RE: 2019 Inspection of Holtwood Fish Passage Facilities

Subject: Inspection of fishways at Holtwood Hydroelectric Project (FERC #1881) on May 22, 2019

Figure 1 - Visible upwelling and potential eddy within the fish lift's tailrace entrances' channel

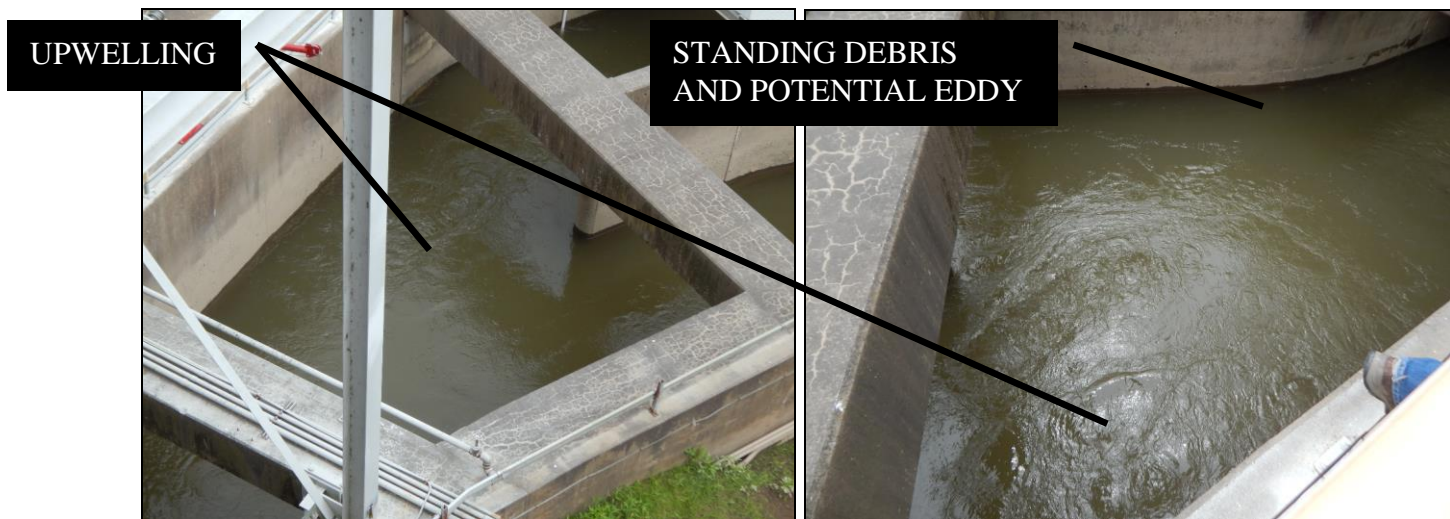
- Visible upwelling over AWS floor diffusers - During the site visit, Service staff identified a location within the Tailrace Channel where excessive hydraulic turbulence was visible from the walking platform (Figure 1). The force of a hydraulic upwelling (i.e., vertically oriented velocity vectors) was clearly extending from a channel floor diffuser, all the way up to the top of the water column. Floor diffusers are designed to introduce additional attraction flow into a fishway through an auxiliary water supply (AWS) system. The Service suspects that for whatever reason (e.g., pushing too much flow through the floor diffuser, or debris issues causing the diffuser to be partially blocked), flow velocities coming out of the floor diffuser were simply too high for this particular entrance channel. This unwanted hydraulic upwelling resulted in a noticeable interruption of the zone of passage inside the Tailrace Channel. In general, hydraulic upwelling should never be visible within the entire longitudinal profile of a well-maintained zone of passage for migratory fish. The Licensee should consider reducing the amount of flow going through the floor diffuser system to ensure visible upwelling is not occurring in the fishway.

- Hydraulic eddy and standing debris within the Tailrace Channel - Immediately upstream of the hydraulic upwelling over the floor diffuser, an apparent eddy was also identified by Service staff (Figure 1). A small amount of debris was seen floating in circles on the outer bend of the right side wall (looking downstream). This could be evidence of the presence of a hydraulic eddy. Hydraulic eddies could become physical interruptions to the zone of passage within a fishway, and could ultimately result in fish delays and/or fallbacks. Unwanted eddies should always be avoided in any successful fish passage facility. Any possible reduction in this condition through flow management through the fishway should be evaluated. Physical modifications to the channel may be required in the future to eliminate this issue if poor fish passage efficiency continues in the entrance channel of the fishway (as noted in telemetry studies).

- b. Visible Upwelling Over AWS Floor Diffusers - Flow going through the diffuser system should be reduced to ensure visible upwelling is not occurring in the fishway.

- c. Hydraulic Eddy and Standing Debris within the Tailrace Channel - Any possible reduction in this condition via flow management through the fishway should be evaluated. Physical modifications to the channel may be required in the future to improve fish passage efficiency in the entrance channel of the fishway.

Figure 2 - Visible large eddy in tailrace and smaller eddies near entrance gates

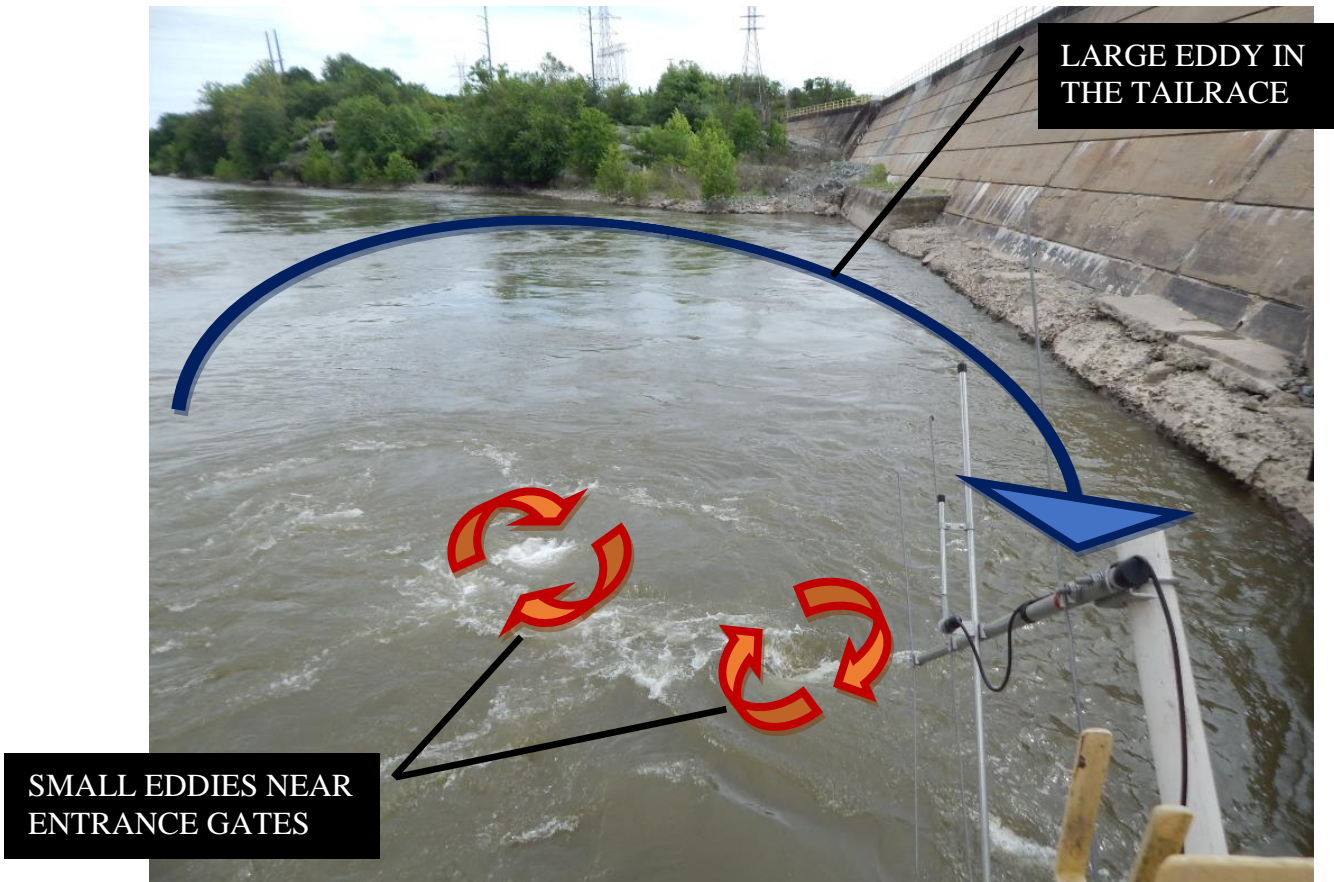
- Continual eddies downstream of tailrace entrance gates - Service staff identified multiple small eddies (Figure 2) that would continuously form in the path of the fish attraction jet flow coming out of entrance Gates A and B (i.e., Tailrace Channel). The Service suspects that a much larger

eddy in the tailrace of the powerhouse (Figure 2) that causes flow to move upstream along the retention wall on the right bank of the tailrace might be the culprit for these smaller eddies within the zone of passage. When the flow from the large eddy moves in the upstream direction towards the entrance gates, it appears to interact with the fish attraction flow coming out of entrance Gates A and B in the downstream direction, resulting in these unwanted smaller eddies. On the day of the site visit, not all of the powerhouse units were generating. The large eddy might or might not be present during other powerhouse operational schemes. Any successful fish passage facility should avoid these type of hydraulic eddies within the dedicated zone of passage for migratory fish. Any possible reduction in this condition through flow management through the fishway and using powerhouse generation should be evaluated. Physical modifications to the tailrace or fishway entrances may be required in the future if poor fish passage efficiency occurs at the entrance of the fishway (as noted in telemetry studies).

- d. Continual Eddies Downstream of Tailrace Entrance Gates - Any possible reduction in this condition via flow management through the fishway combined with powerhouse generation should be evaluated. Physical modifications to the tailrace or fishway entrances may be required in the future to improve fish passage efficiency at the fishway entrance.

Figure 4 - Crowder screen missing

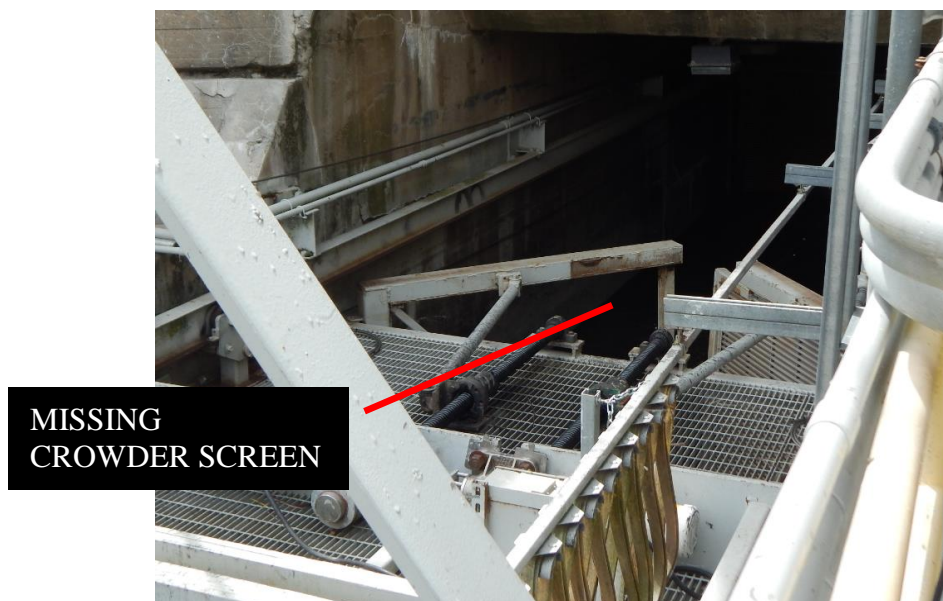
- Missing crowder screen - One of the crowder wings (right wing looking downstream) in the Tailrace Channel was missing its metal screen (Figure 4). If the fish can move freely through the crowder during a lift cycle, then a high rate of fish fallbacks, even after reaching the holding pool, should be expected. The crowder screen should be in good condition during the migratory season so that the fish can be effectively crowded onto the lift hopper. Please verify the status of the repair of the screen.

- a. Missing Crowder Screen - Please verify the status of the repair of the screen.
- 4. Additional Observations
 - a. Gap in Crowder Wings - Modifications to crowder operation, including reducing the gap in the crowder wings should be evaluated to improve fish passage efficiency in the entrance channel.
 - b. Spillway Channel Eddies - Any possible reduction in this condition via flow management through the fishway should be evaluated. Physical modifications to the channel may be required in the future to improve fish passage efficiency through the entrance channel.
 - c. Bolt Protrusion - Please ensure there are no protruding objects in the fish's path of travel within the fishway that may injure the fish.
